Product Change Notification: E-21-003453

PCN Date: 06-APR-21

DEUTSCH DT 4,6,8,12-Way Plug and Receptacle Housing Change and Add Second Manufacturing Location

Logo and Text

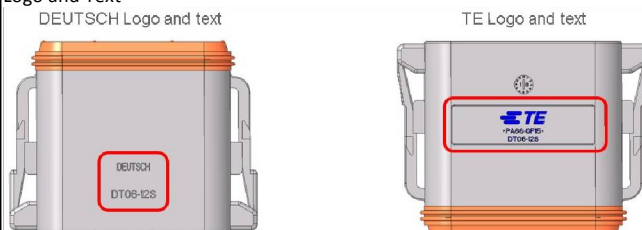
TE-ICT is releasing new capacity tools and making slight form changes to DT 4,6,8,12-Way plug and receptacle housing part numbers, listed below. Changes include: Plug front seals will use seal retention version, logo and part number text, latch ends, and rounded edges. See pictures below and attached presentation for details, 4 and 12-way shown as an example. Also, as part of this initiative, TE-ICT is adding a second manufacturing location in China. CN will be added for those PNs manufactured in China to indicate the country of origin. These PNs are TE proprietary designs, therefore considered catalog/general market product. PPAP and/or sample requests must be submitted via ict-ppap-request@te.com or ePPAP system. PPAPs will be completed by part family and will be available upon request only. All PPAP requests must be received within 14 days of receipt of this notification. Product drawings are affected and will be updated as the changes are phased in.

Original Seal to Retention Seal
